SUNDRY NOTICES AND REPORTS ON WELLS

1. OIL WELL ☐ GAS WELL ☐ OTHER ☒	7. UNIT AGREEMENT NAME
2. NAME OF OPERATOR CONOCO INC.	8. FARM OR LEASE NAME AXI Apache "P"
3. ADDRESS OF OPERATOR P. O. Box 460, Hobbs, N.M. 88240	9. WELL NO. 3
4. LOCATION OF WELL (Report location clearly and in accordance with any State requirements.* See also space 17 below.) At surface Unit M 990' FSL & 990' FWL	10. FIELD AND POOL, OR WILDCAT Ballard Pictured Cliffs
14. PERMIT NO. 30-039-08084	11. SEC., T., R., E., OR BLK. AND SURVEY OR AREA Sec. 17-23N-4W
15. ELEVATIONS (Show whether DF, ST, OR, etc.) BUREAU OF LAND MANAGEMENT FARMINGTON RESOURCE AREA	12. COUNTY OR PARISH Rio Arriba
	13. STATE NM

Proposed P₄A Sketch (Revised)
 AXI Apache P #3

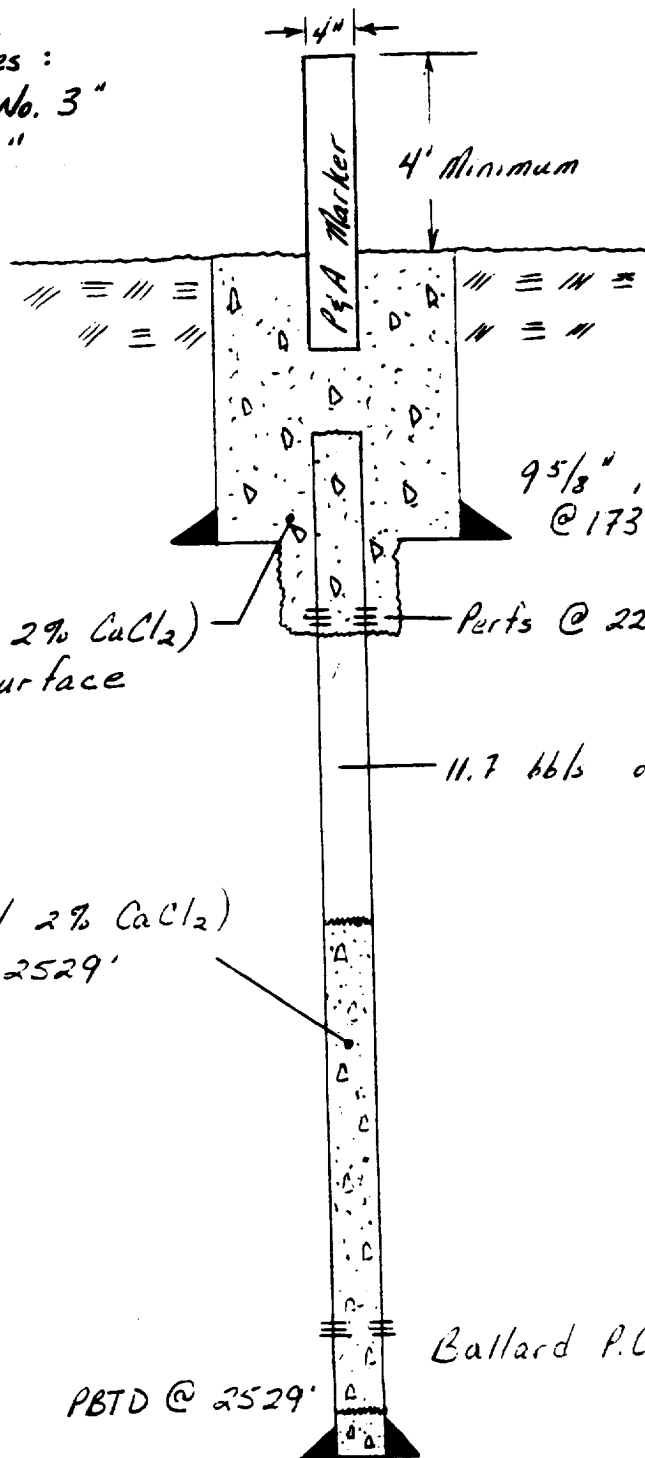
- ① This procedure is different than the approved procedure of 12-27-86.
- ② MIRV, Bullhead 70 sxs class "B" cmt w/ 2% CaCl₂ down 3 1/2" csg. (This volume will fit in the csg w/ the Top below the point to perforated for the surface cmt plug)
- ③ Fill hole w/ weighted pkr fluid and then pump 5 add'l bbls of pkr fluid to squeeze 25 sxs cmt into perfs. Will not exceed 2000 psi surface press. Tag TOC @ 1500'
- ④ Perf @ 223' w/ 4 JSPF. Establish circ. & pump 90 sxs class "B" cmt w/ 2% CaCl₂ and circ. to surface. Will not exceed 3000 psi surf. press.
- ⑤ Cut off csg 3' below final restored ground level & install abandonment marker. Clean location and rig down.
- ⑥ A proposed P & A wellbore sketch is attached.
